WORKPLAN FOR ADDITIONAL MONITOR WELLS
FOR MODEL REFINEMENT DSGWRD 26 – 020
AND
WELL ABANDONMENT PLAN-MONITOR WELL G-19
DSGWRD 26 – 045

MONTROSE SITE
TORRANCE, CALIFORNIA

Re: Submittal of Final Workplan for Additional Wells for Model Refinement (DSGWRD26-020),
And Well Abandonment Plan-Monitor Well G-19 (DSGWRD26-045)
Montrose Site, Torrance, California

RESPONSE TO EPA COMMENTS ON
DRAFT WORK PLAN FOR ADDITIONAL MONITOR WELLS
FOR MODELING REFINEMENT
DSGWRD 26-20
MONTROSE CHEMICAL SUPERFUND SITE
LOS ANGELES, CALIFORNIA
DATED AUGUST 16, 2004

FIGURE 15

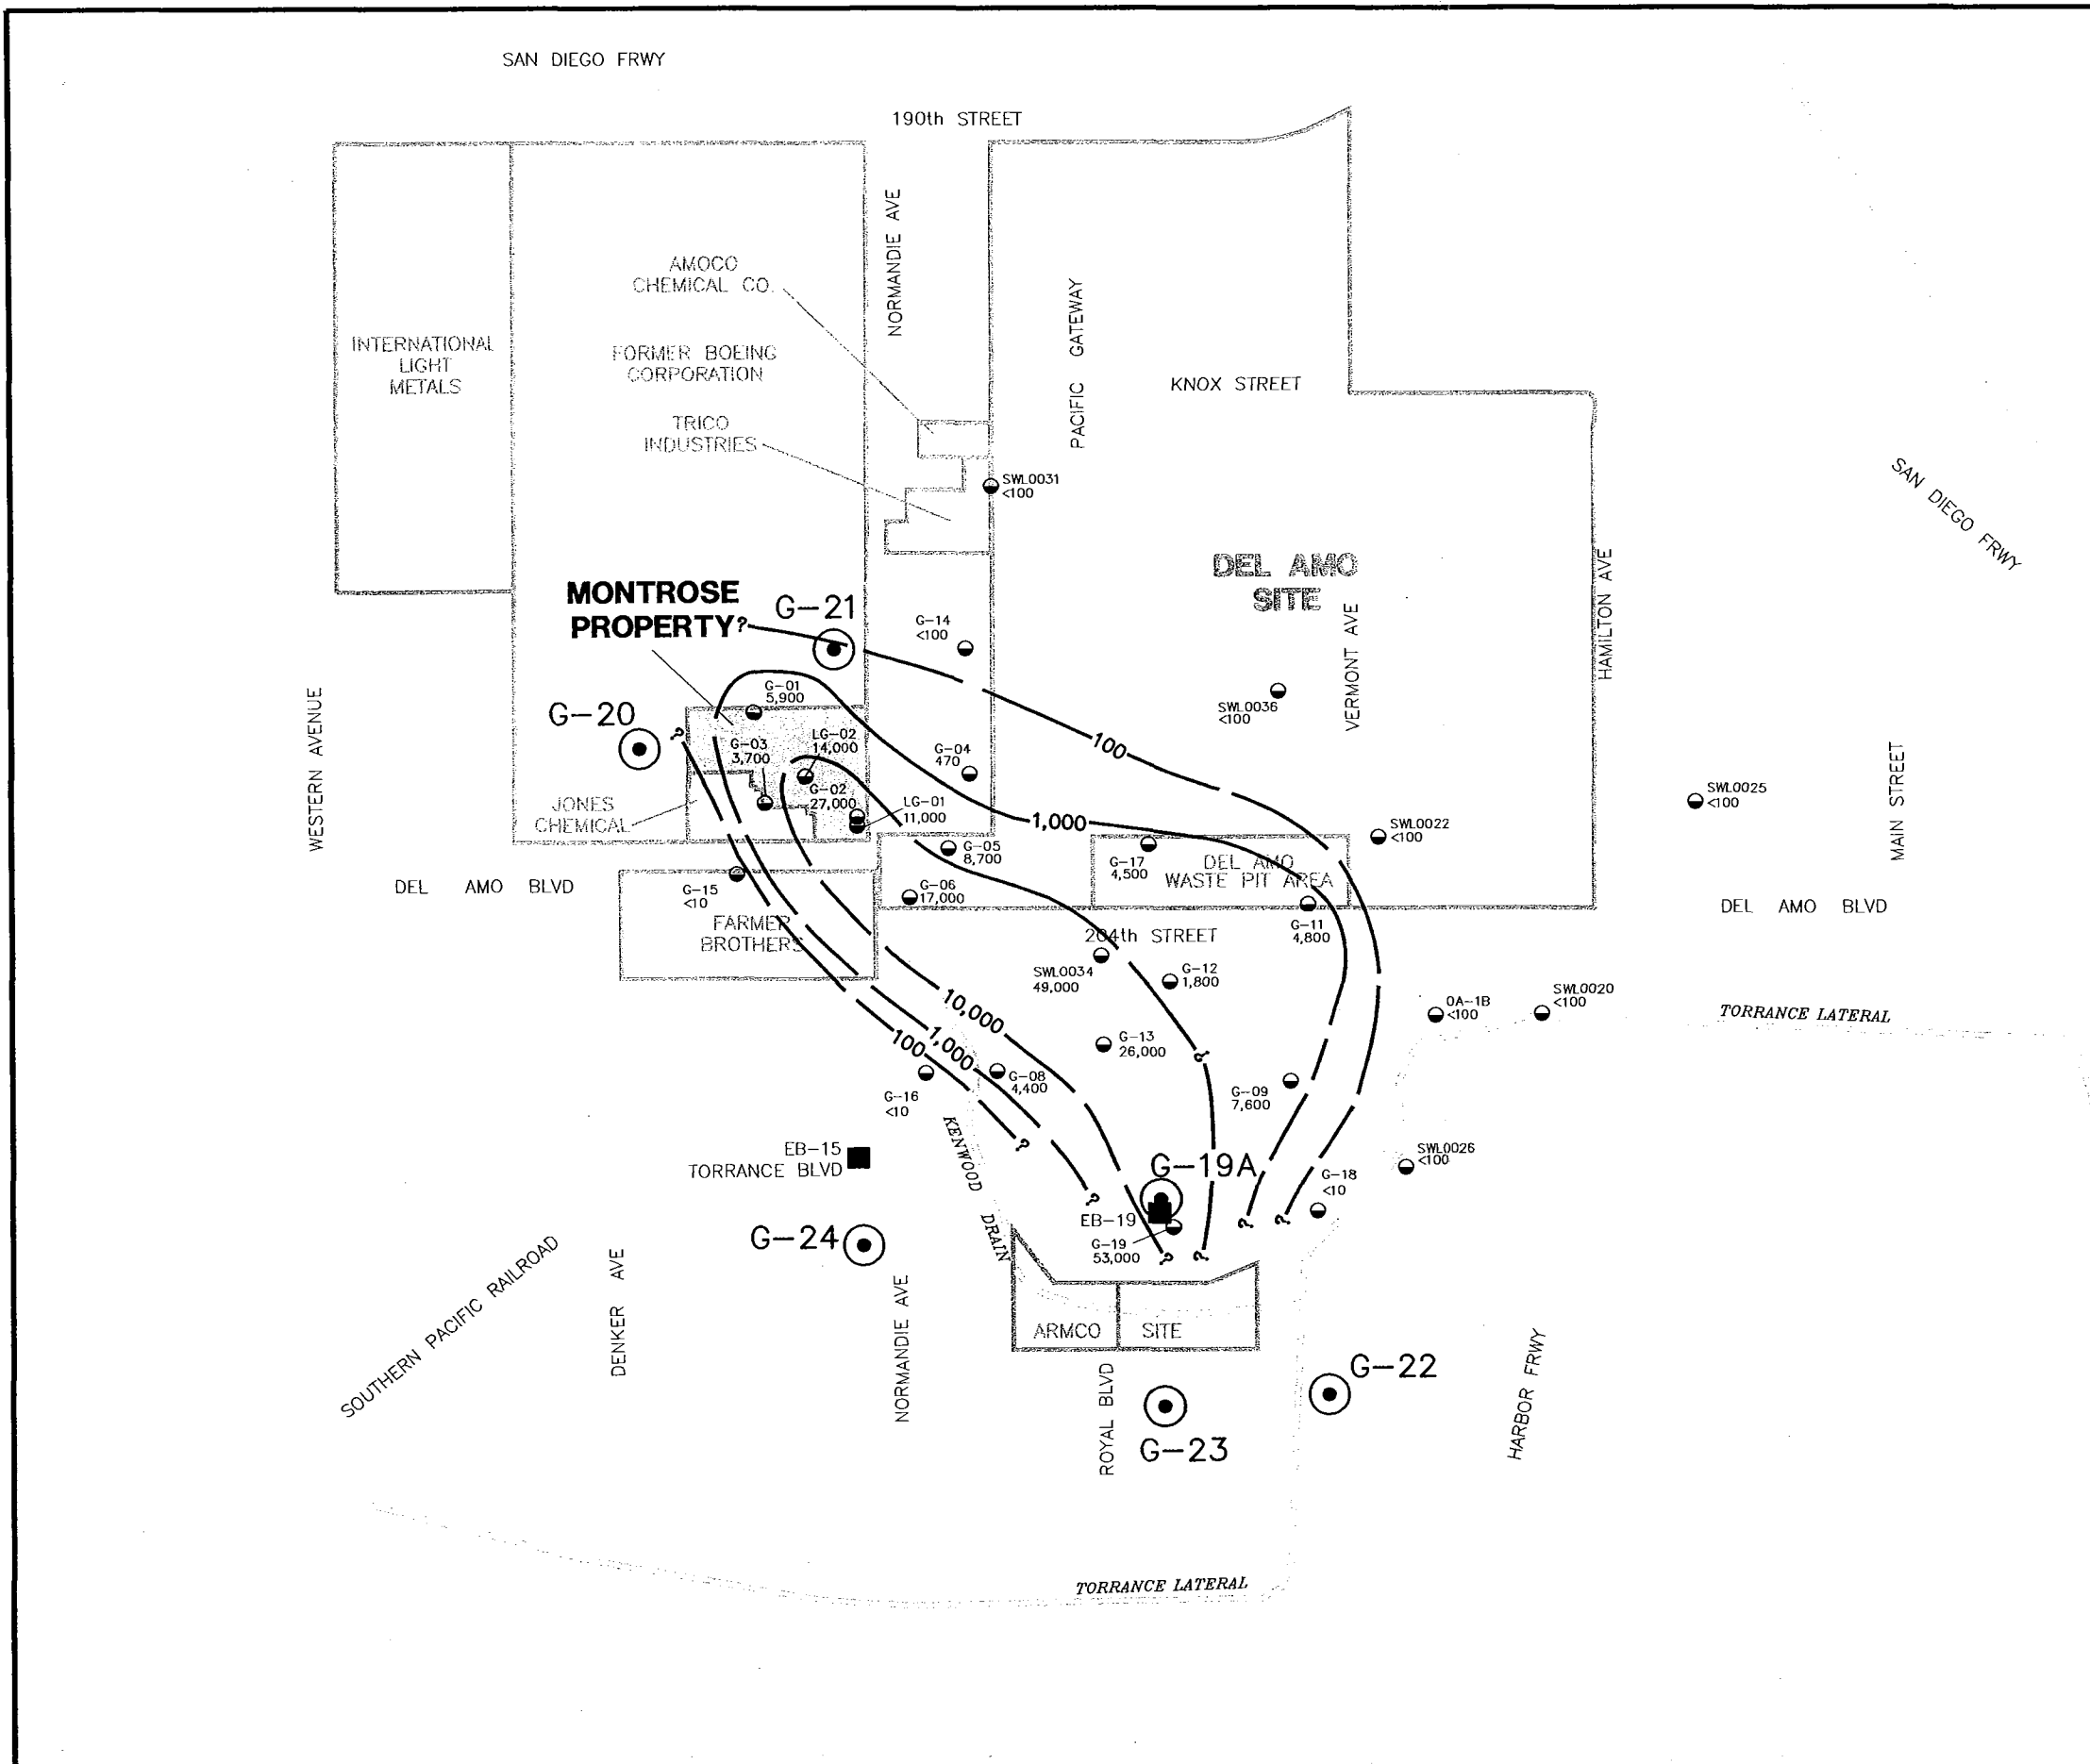
4. Section 4.2, beginning on page 14, describes a two-phase field program designed to evaluate whether well G-19 may have a failing well screen which is allowing contaminants to leak from the Bellflower Sand into the Gage Aquifer. The first phase involves comparing geochemical signatures of the water in the Bellflower Sand and Gage Aquifers. The second phase involves a sequential low-flow purging and sampling from distinct 10 foot zones within the screened interval of the well. The second and third paragraphs on page 16 indicate that if the phase 2 result reveals that samples from the upper portion of the screened interval have higher concentrations compared to the lower portion of the interval, then the well will be destroyed.

- The Refinement Plan should state that the potential vertical seepage in well G-19 will be assessed to determine (1) if the continuous Gage Aquifer plume is present at the location of this well, or the area of high concentrations is localized in the immediate vicinity of the well due to leakage through the well casing, and (2) if the well needs to be destroyed. Montrose should consider whether, before it is abandoned (assuming it is), additional information critical to the modeling effort can be obtained from G-19 so that the need to install another well at the same location may be avoided. Montrose should develop a description of the logic process (a definitive logic diagram is not needed, but the approach should be clear), various tools available to assess the well and meet the objectives, what the indications from each type of evaluation of the well might be, etc.

- The Refinement Plan does not mention the results from Phase 1, geochemical signatures, at all. The plan should indicate how the results from Phase 1 will affect the decisions needed to meet the objectives.

- It is certainly possible that, even without leakage through the well, concentrations could be higher in the upper part of the aquifer as compared to the lower part, especially when compared on 10-foot increments. Please discuss this in relation to how the information from this phase will be used and uncertainties associated with it, discussion of the (presumably) low cost associated with this approach, and the degree of usefulness associated with the various possible outcomes of this test.

- It should be explained in the Refinement Plan that if the highest concentrations are encountered in the middle or lower portion of the screened formation, it will likely indicate that chlorobenzene migrated to the well from the upgradient location. On the other hand, the results of this testing may not be conclusive, if high chlorobenzene concentrations are encountered in the upper portion of the screen, or if concentrations are uniform throughout the screened interval.

- The Refinement Plan should state that if the results of Phases I and II are not conclusive, other options will be considered during Phase III and discussed with EPA. For example, another

option for evaluating the well would be to pump it fairly strongly, and see if concentrations reach a point where they suddenly drop. If the Gage Aquifer is truly contaminated at the levels indicated by the concentration in the well, then the levels should not change much after the purge volume is removed. If the well is leaking, then the contaminant concentrations in effluent groundwater will likely drop significantly in the course of pumping because the lateral extent of the high-concentration plume is expected to be limited to the proximity of the well. Water levels should be also monitored during pumping in the MBFC Sand well BF-24 to assess the hydraulic connection between the MBFC Sand and Gage aquifers at this location. This option would, of course, imply incurring costs for disposal of the water. The potential for the pumping to be performed after the treatment system for the pilot test is in place near the Armco site should be explored.

RESPONSE: Due to the uncertainties involved, Montrose has decided to not perform the evaluation of monitor well G-19, and has instead elected to replace the well with a new monitor well designated G-19A, which will be located directly upgradient from monitor well G-19. The text of the workplan has been revised to reflect this proposed action. The proposed design of monitor well G-19A has been added to Table 4. The proposed location of monitor well G-19A has been added to Figure 15.

If the results from monitor well G-19A indicate that the water quality data obtained from monitor well G-19 are not representative of the Gage aquifer in this vicinity, then monitor well G-19 will be properly destroyed in accordance with the procedures outlined in the Workplan.
